**HUDSON RIVER PCBs REASSESSMENT RI/FS
RESPONSIVENESS SUMMARY FOR
VOLUME 2A: DATABASE REPORT
VOLUME 2B: PRELIMINARY MODEL CALIBRATION REPORT
VOLUME 2C: DATA EVALUATION AND INTERPRETATION REPORT**

DECEMBER 1998

**U.S. Environmental Protection Agency
Region II
and
U.S. Army Corps of Engineers
Kansas City District**

**TAMS Consultants, Inc.
Limno-Tech, Inc.
TetraTech, Inc.
Menzie-Cura & Associates, Inc.**

Figure 9. Summer 1991 congener peak TIP PCB loading - a) water column load; b) calculated diffusive sediment load; c) unaccounted-for load; d) negative congener loadings.

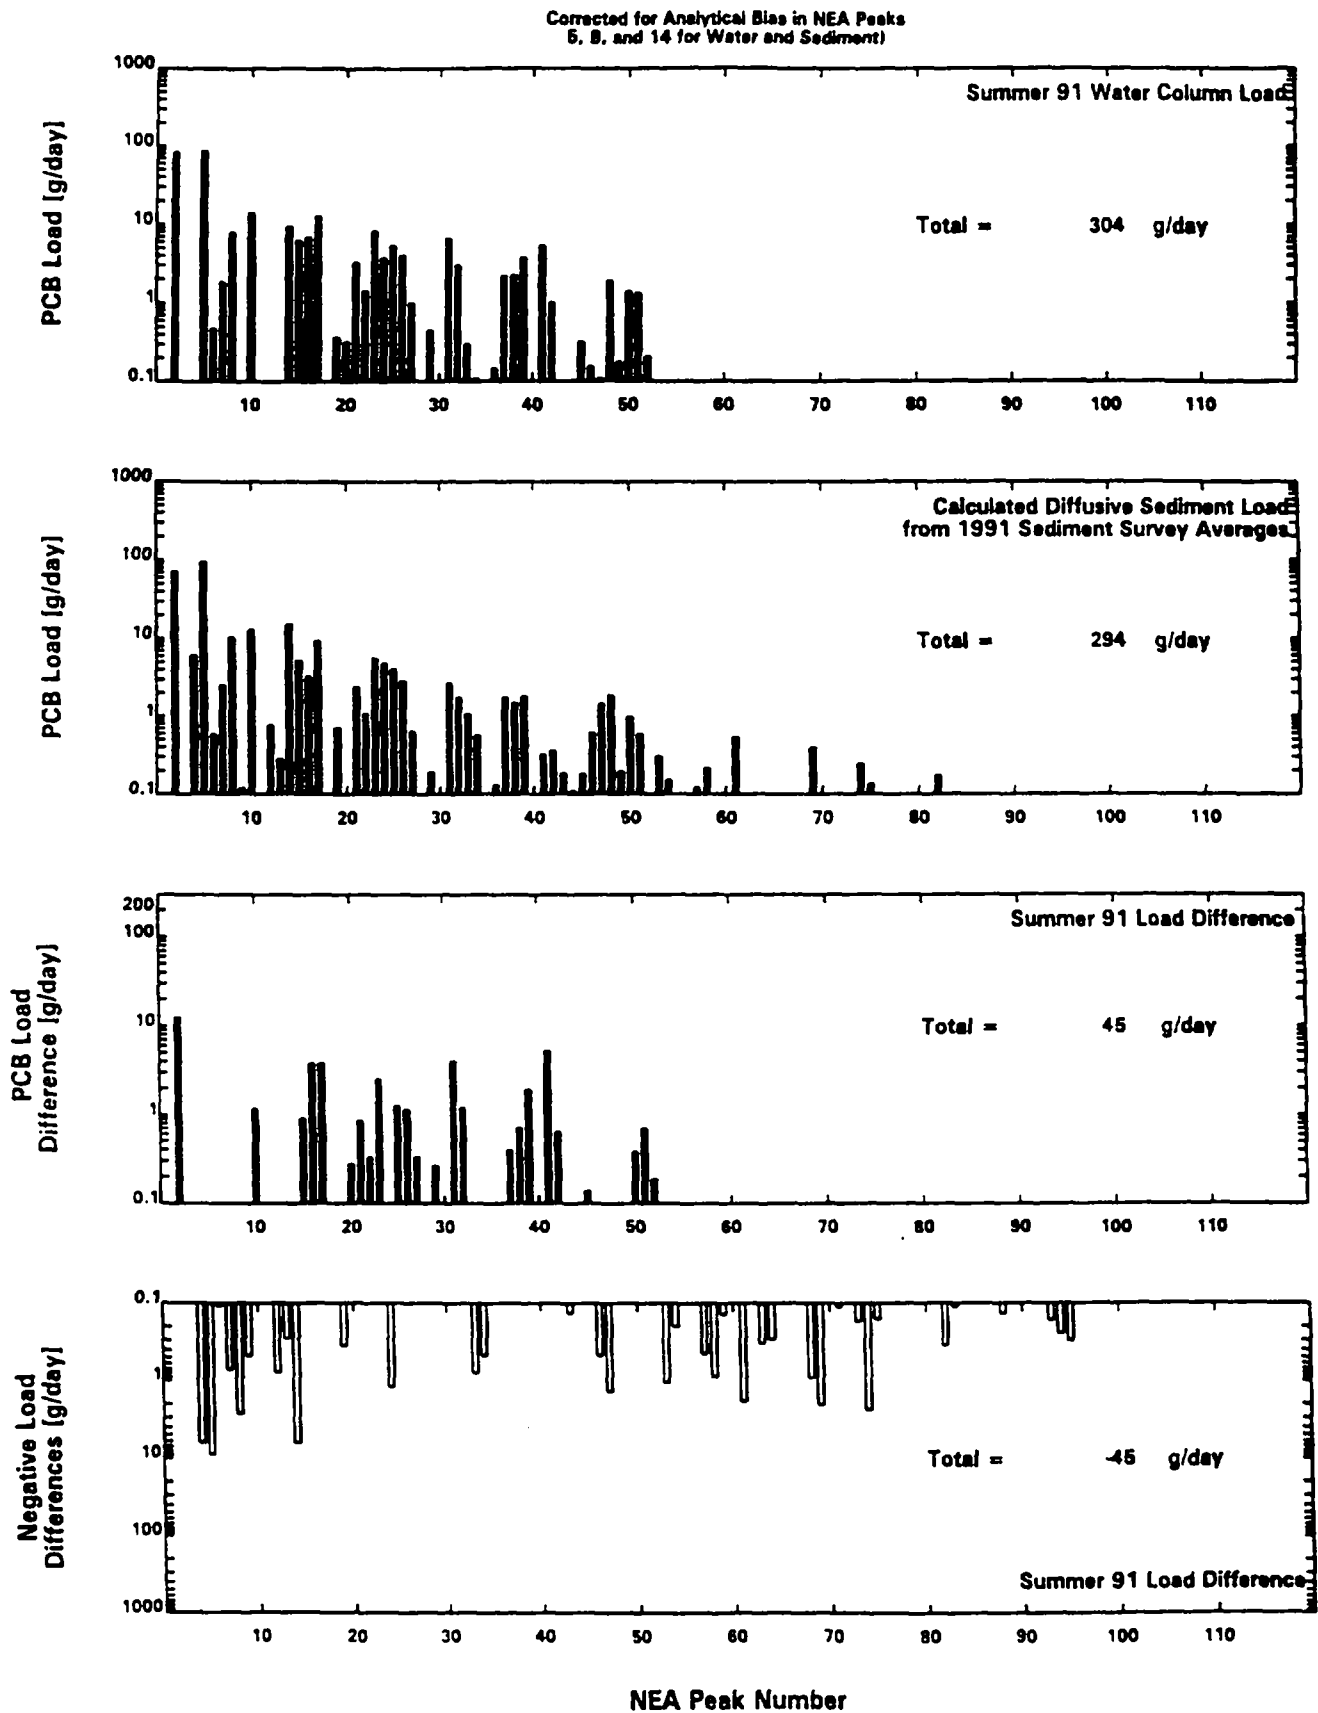
The sediment water exchange coefficient (K_f) can be estimated by substituting the water column PCB congener flux estimates for the summer low flow period of 1991 into Equation 10 and adjusting K_f to minimize the sum of differences in individual PCB congener loading estimates. Negative PCB congener loadings due to detection limits for the higher PCB congeners in water column samples are disregarded (Figure 9; panel d).

Figure 18. Steady state food web model simulation of T1P (exposure: realistic water, top 0-2 cm of sediment, see Table 6).

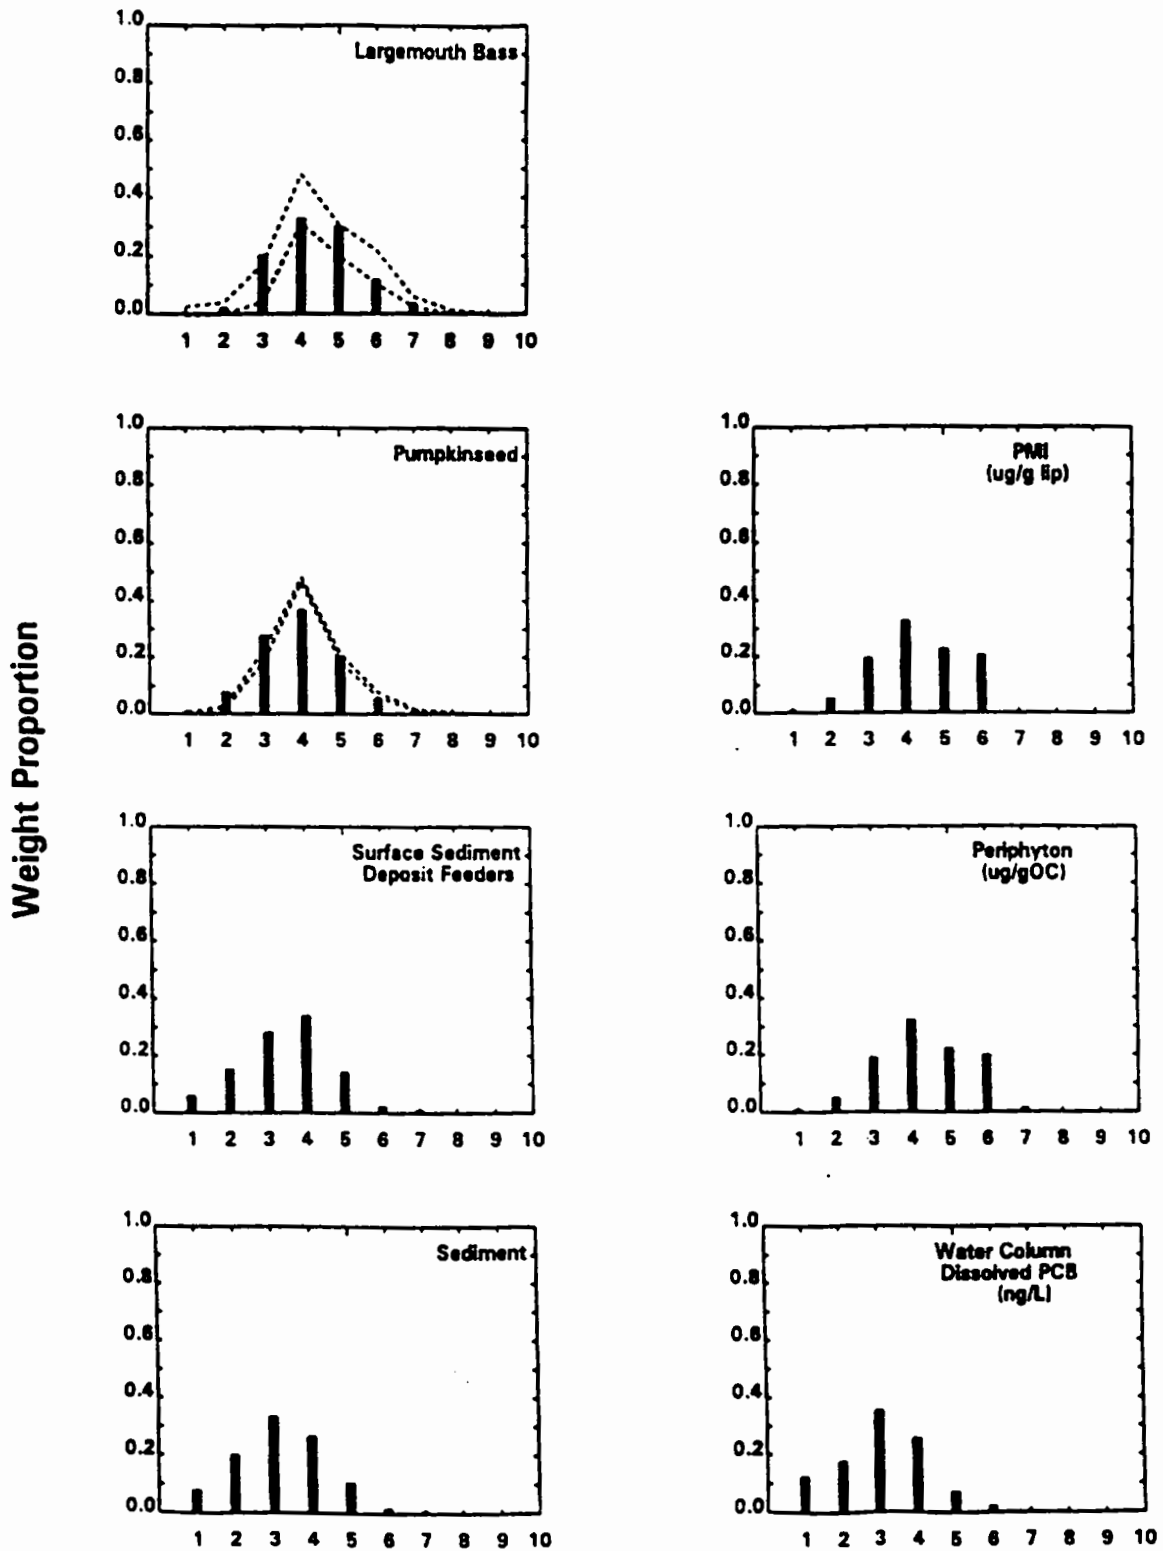
The data best match pumpkinseed homologue distributions computed using the surface slice of the high-resolution cores and the measured water column distribution (Figure 18). The largemouth bass distributions computed using either surface slices, 0-2 cm (Figure 18) or the 0-5 cm layer (Figure 19) best reproduce the observed distributions. As the degree of dechlorination in the exposure sources increases, the model results diverge from the measured homologue distributions

Figure 22. Relationship between PCB congener dechlorination ratios and number of chlorines per biphenyl in EPA Phase II high resolution sediment cores.

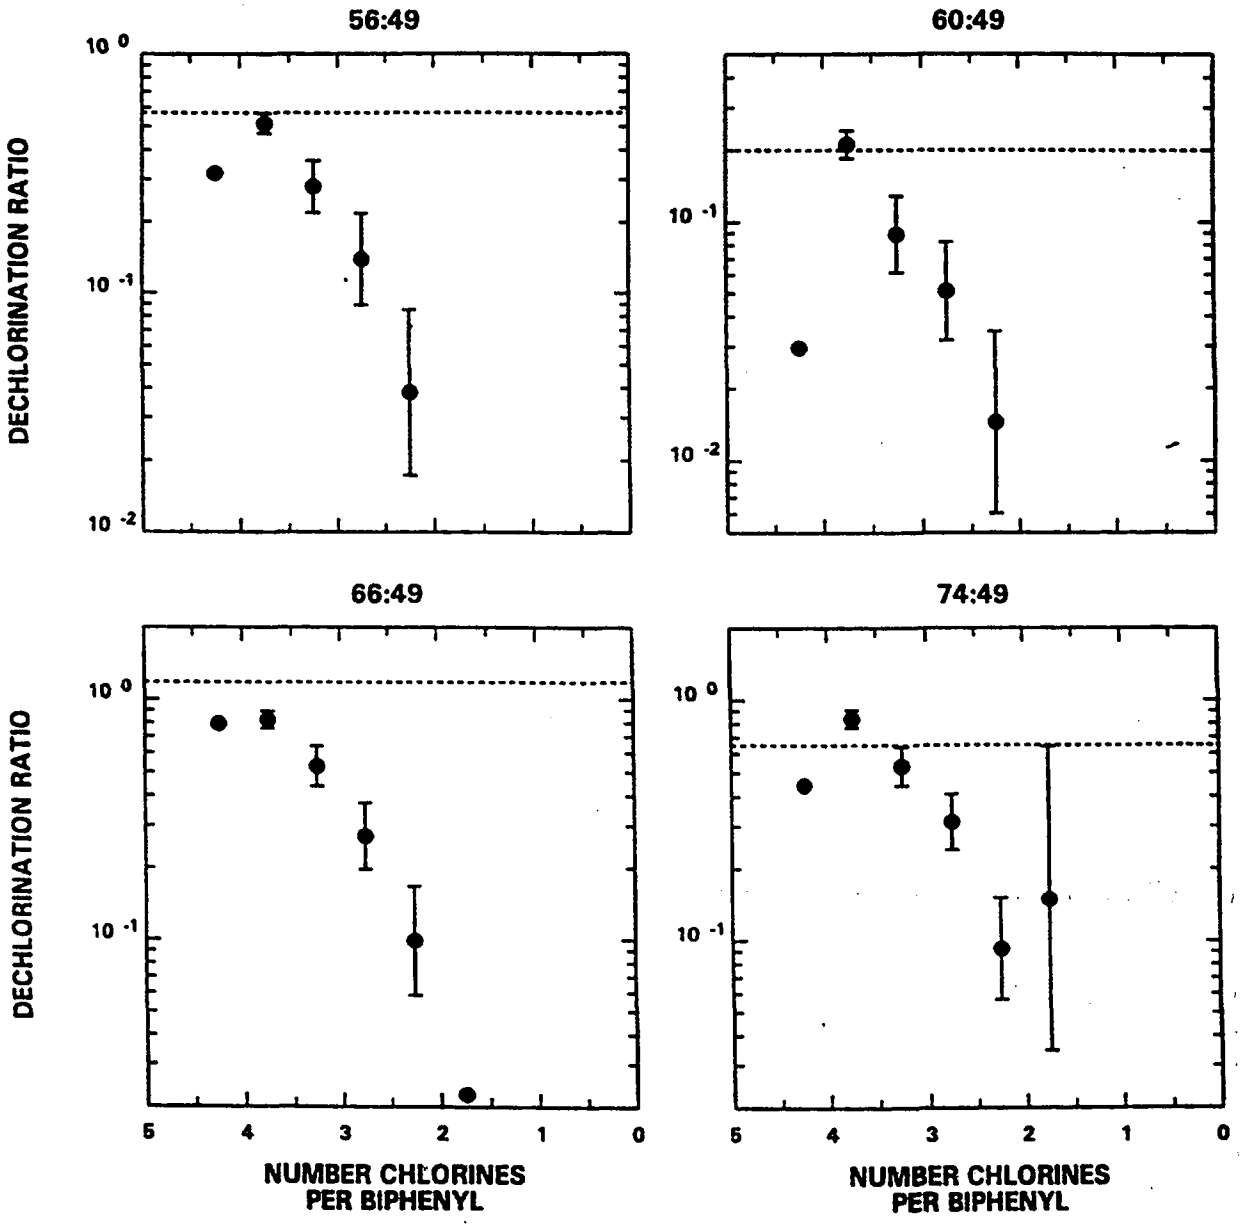
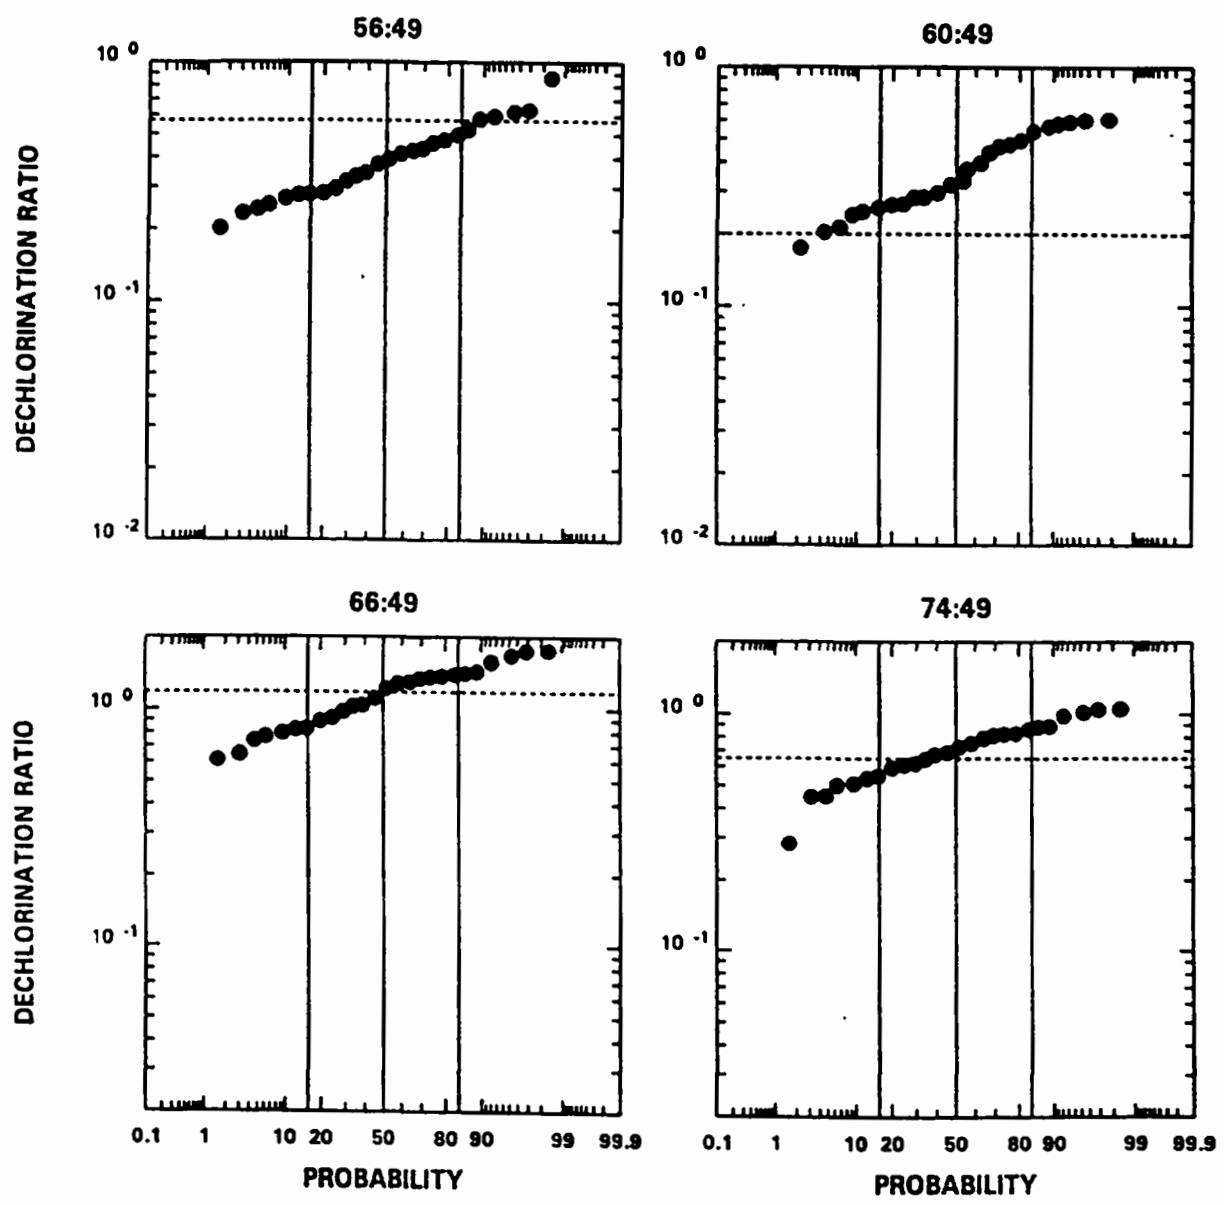
These ratios decline as dechlorination proceeds. For example, four of these ratios are plotted against the number of chlorines per biphenyl (Cl/BP) using high-resolution core sediments from the Upper Hudson (Figure 22). The dashed lines indicate values of the ratios and Cl/BP for Aroclor 1242. The ratios in the sediments approach the Aroclor 1242 value in samples in which Cl/BP approaches the Aroclor 1242 value. In addition, values of the ratio decline in dechlorinated sediments.

Figure 25. Cumulative PCB DNAPL oils collected from seep 13 (1996-1997).

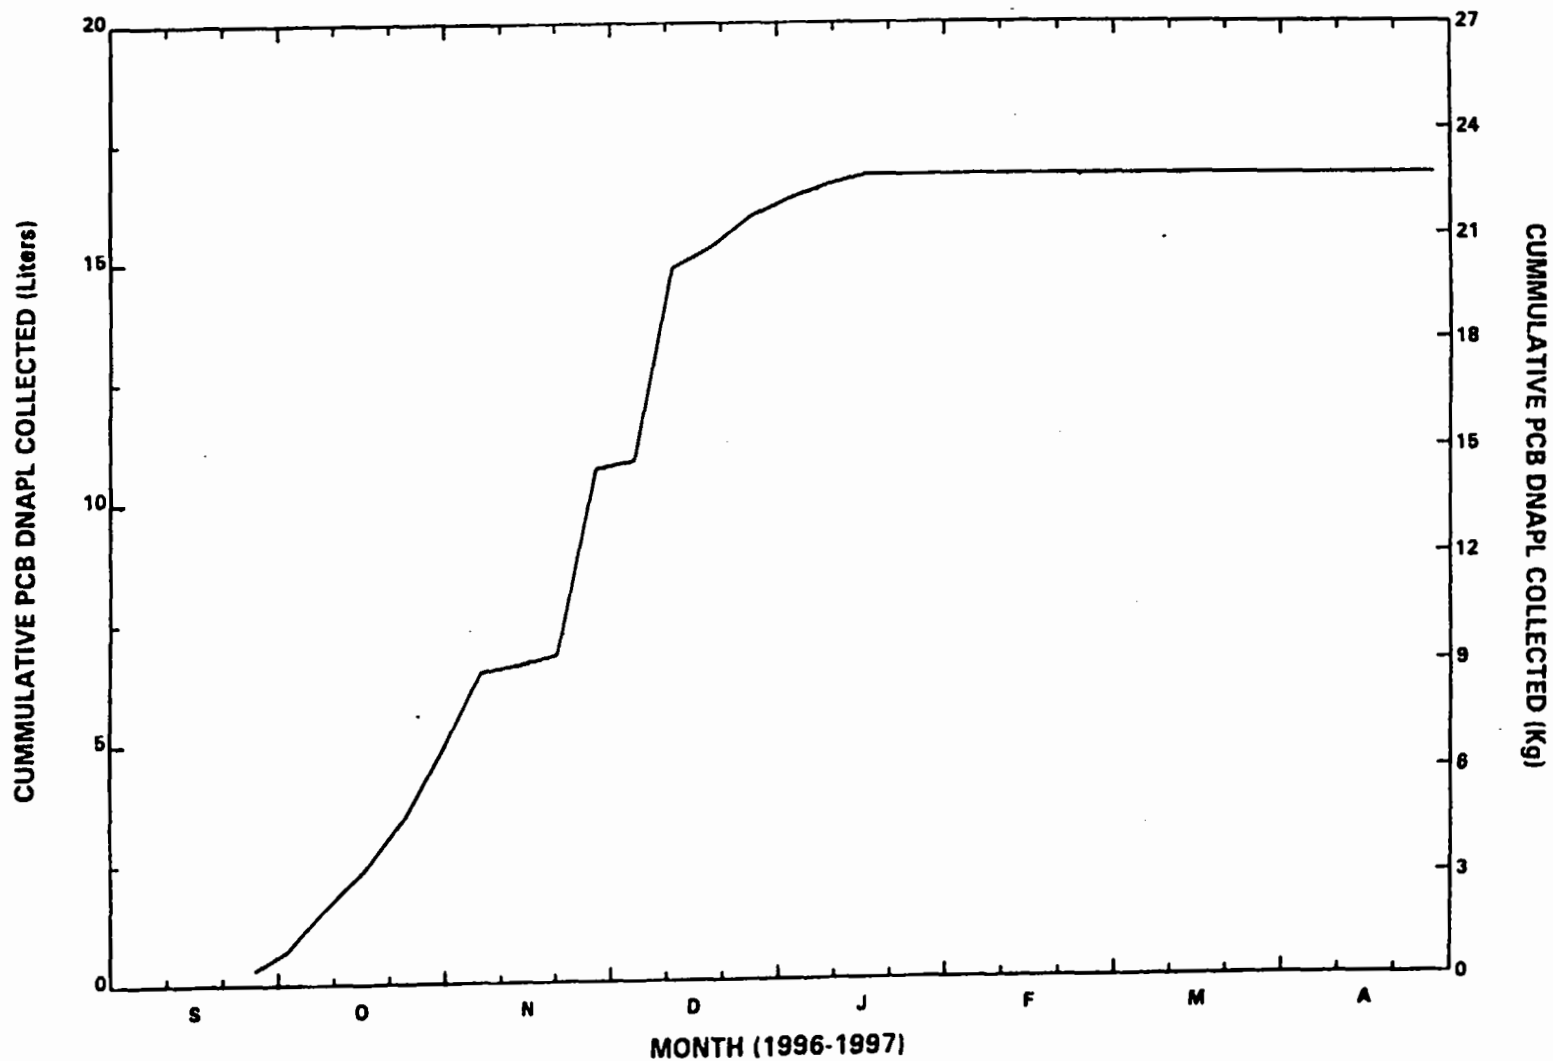
⁷ Localized groundwater pumping efforts appear to have mitigated PCB losses through Seep 13 (Figure 25).
